ADDENDUM NUMBER FOUR

Project: Lawrence Fire Station #38

Construction Manager: Garmong Construction Services

ITEM 1 – BIDDER'S Q&A (Bold is added or revised)

1. See attached Drawing A120A from DELV Design.

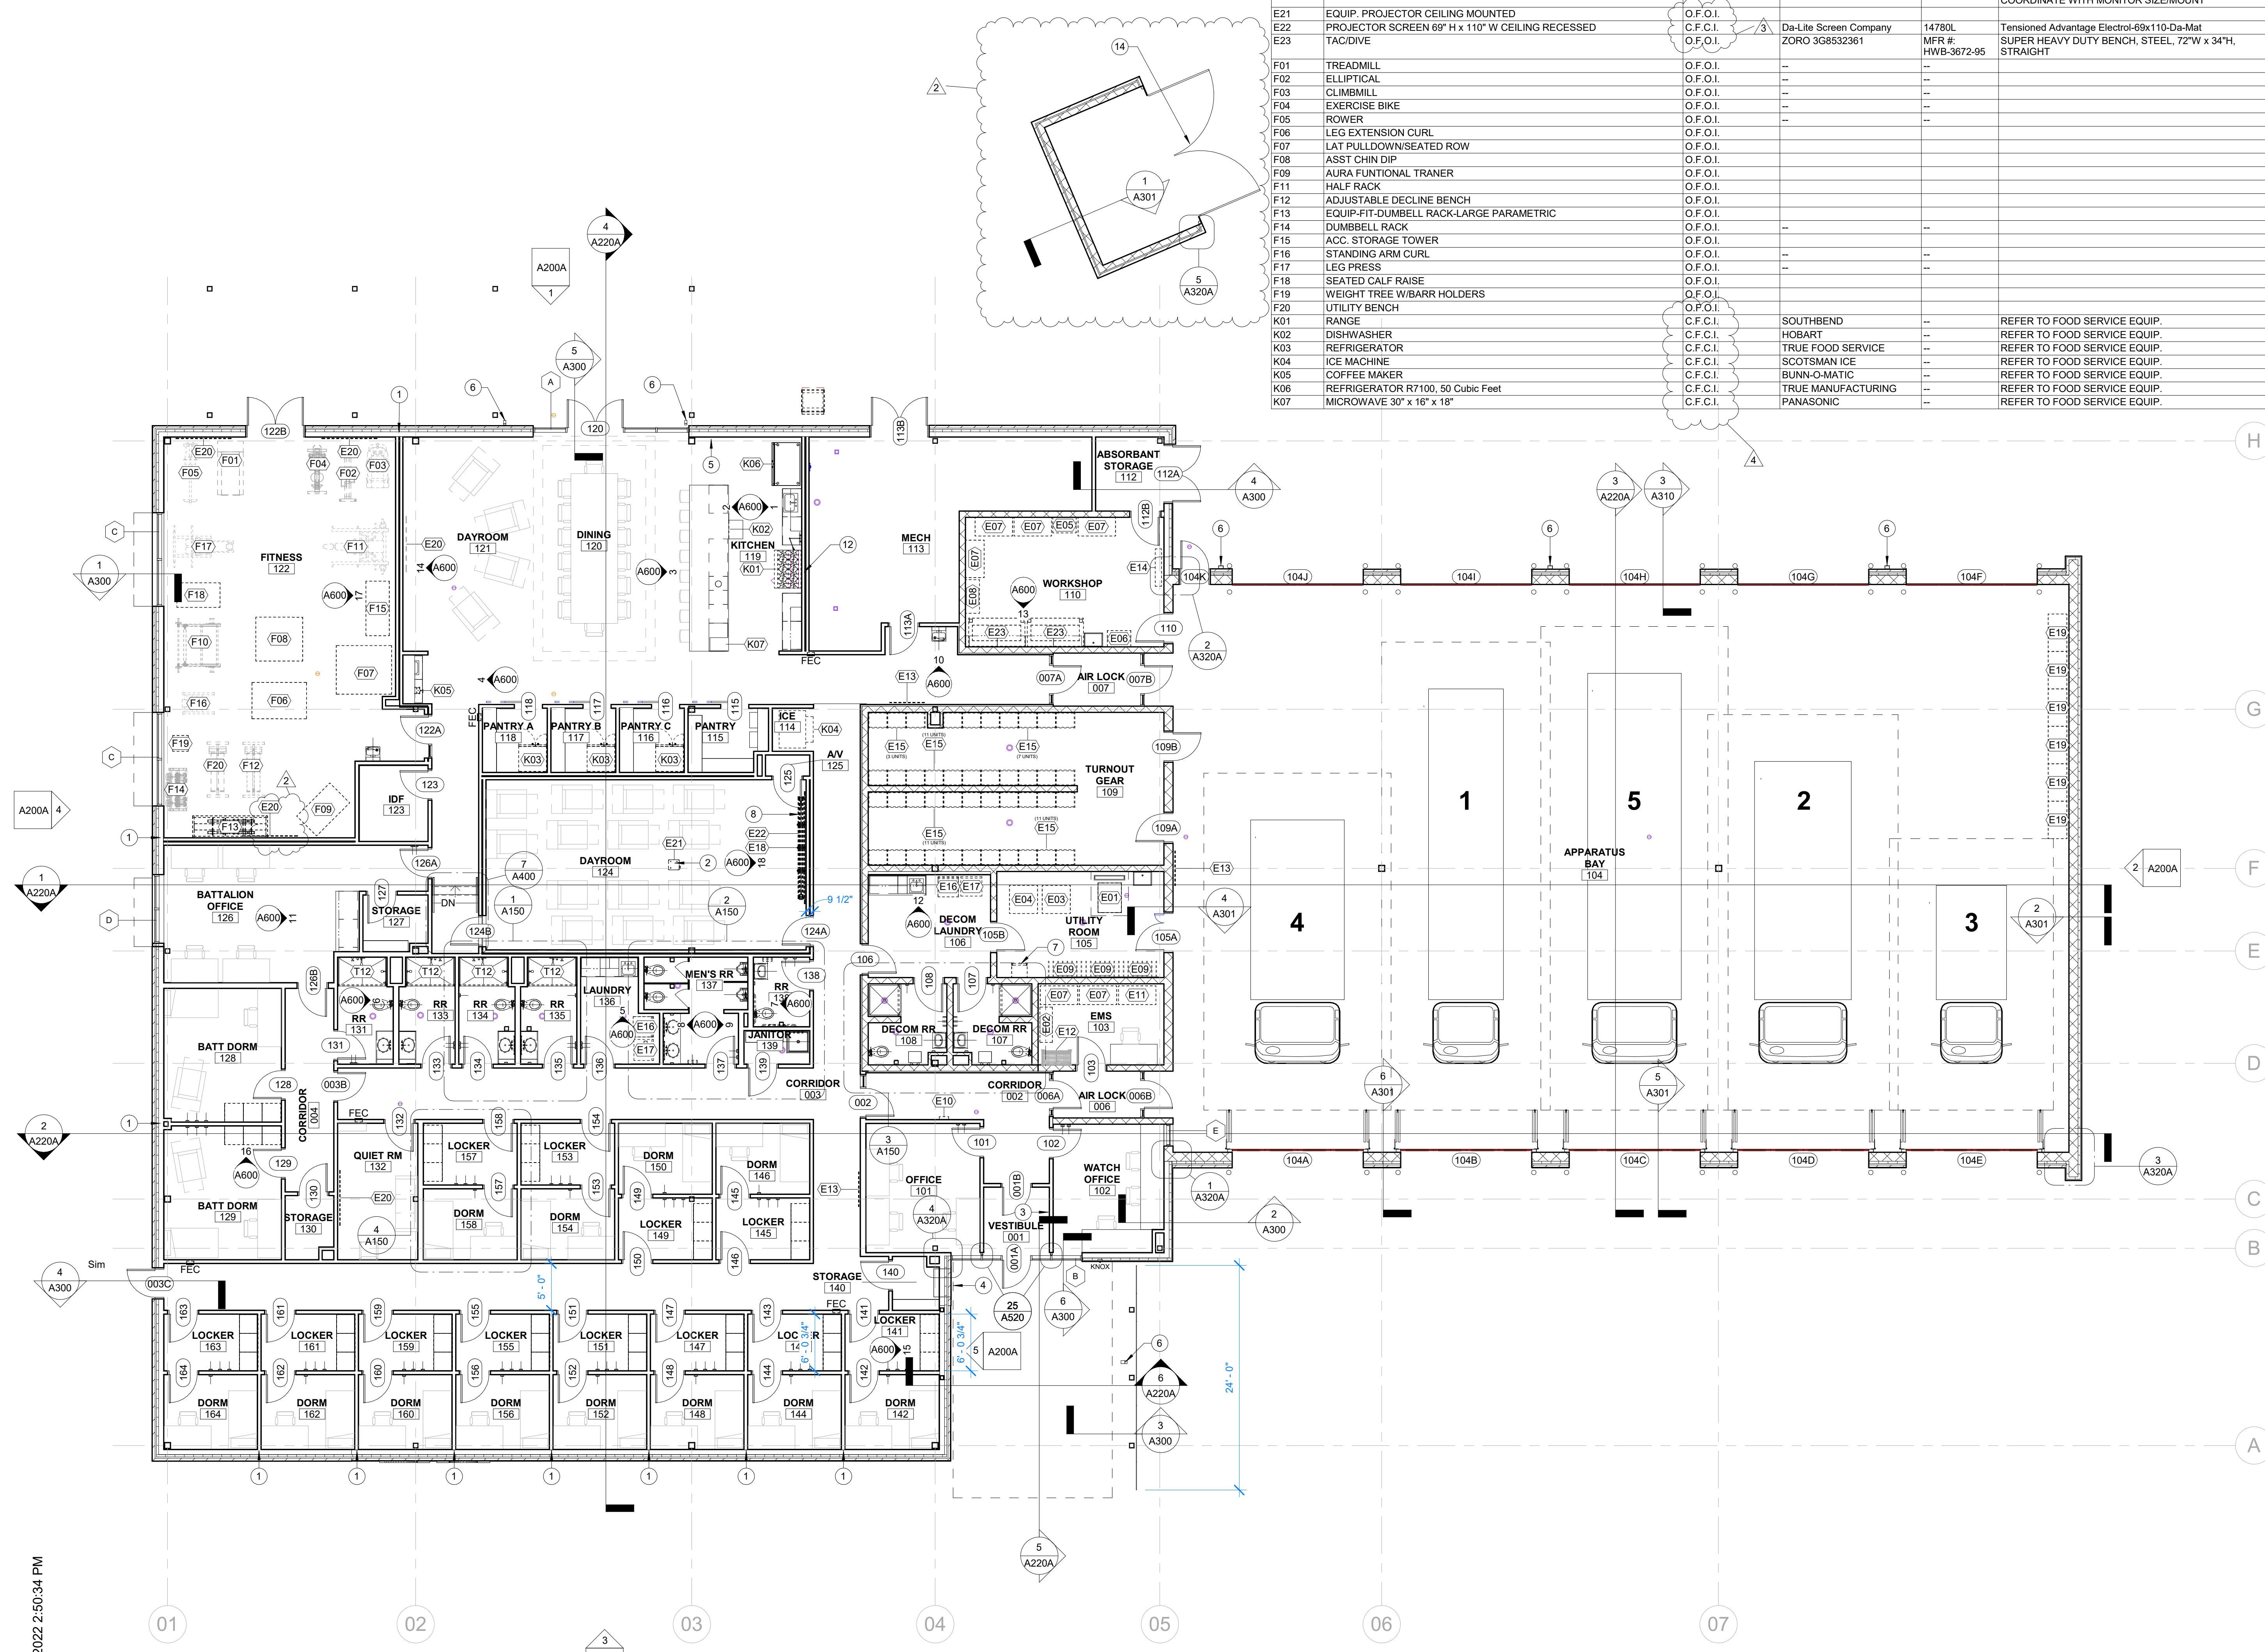
RFI #35 Q: Equipment E18 (A120A) is a 12'x4' white markerboard that is contractor furnished and installed. Will we get a spec?

A: A Remark will be added in the Equipment Schedule for E18, to read as follows, "PROVIDE CLARIDGE SERIES 2000 PORCELAIN ENAMEL STEEL MARKERBOARD IN WHITE WITH ALUMINUM TRIM."
